1978 Corvette: Service Bulletin: Removable Roof Panel Fit

Subject: Removable Roof Panel Fit
Model and Year: 1978 Corvette
Source: Chevrolet Dealer Service Technical Bulletin
Bulletin No: 78-T-23
Section: I
Date: April, 1978

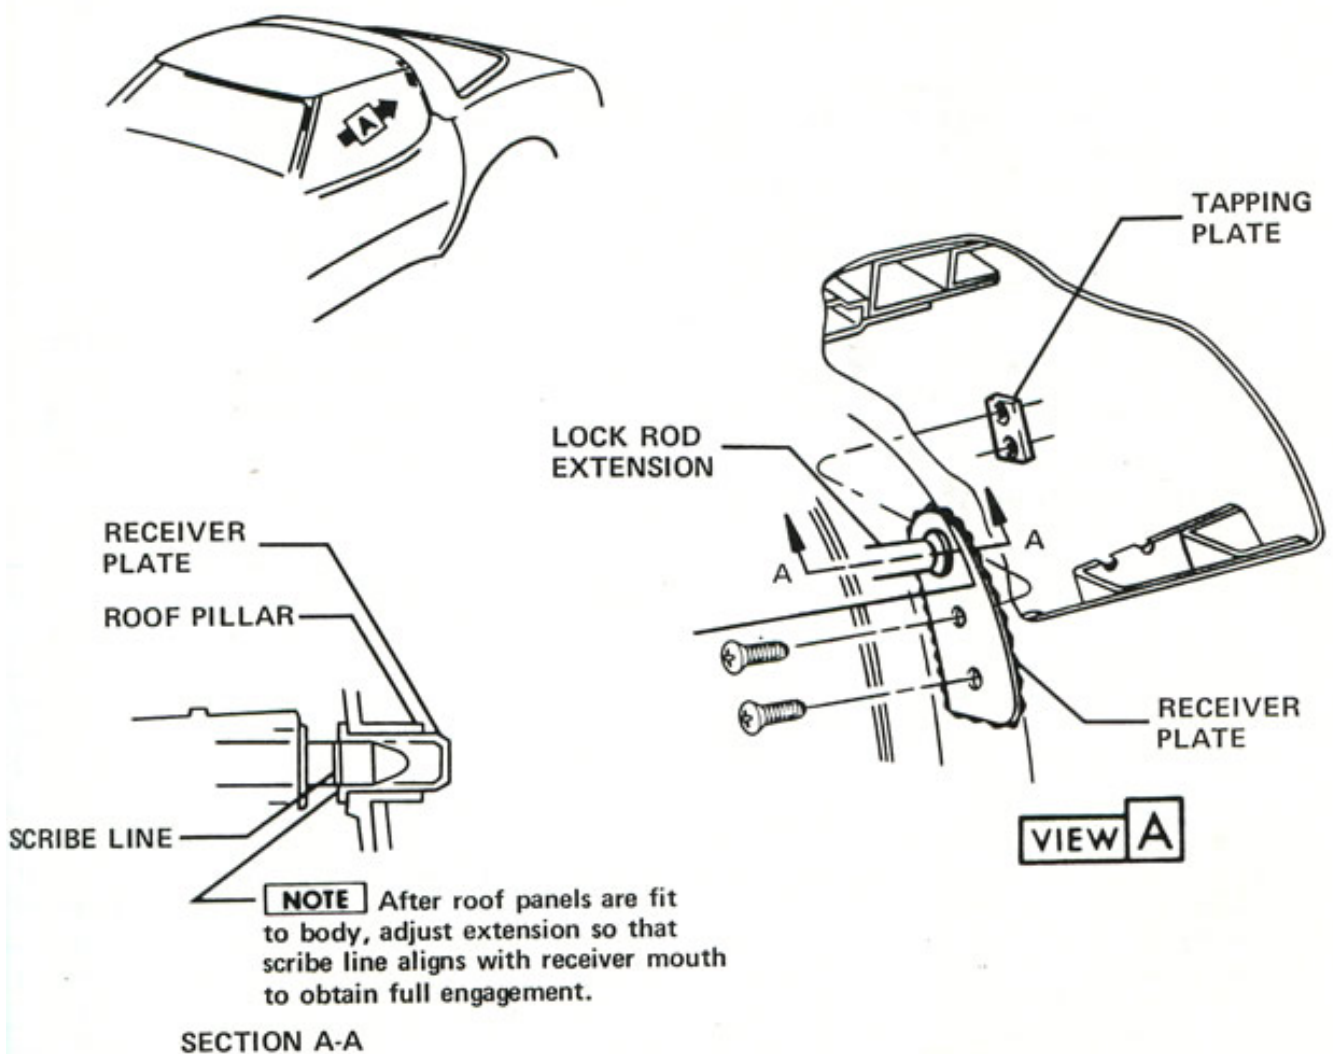
Some early 1978 Corvette removable roof panels may be bowed in relation to the windshield header and/or rear roof. This condition can be caused by an improperly positioned roof lock receiver plate.

The bow in a roof panel can be eliminated by lowering the roof lock receiver plate as outlined below:

1. Remove the rear roof corner garnish and lower roof trim panel.
NOTE: It is not necessary to remove the shoulder belt or retractor.
2. Remove the roof lock receiver plate screws. Hold the tapping plate, located behind the roof pillar, to prevent it from falling (see illustration on page 2). Remove any excess sealer from pillar and receiver plate.
3. Using a small round file, elongate (lower) the three holes in the roof pillar as required to obtain a relaxed roof panel with a flush fit. This will be a trial and error process of installing the receiver plate and checking that the roof panel lock rod extension engages easily.

4. When an acceptable roof panel fit is achieved, thoroughly pack the area behind the receiver plate with 3M Strip-calk or equivalent.
5. Reinstall interior trim panels.
6. Adjust the door glass to the roof weatherstrip as described in Section 2D, 1978 Service Manual.
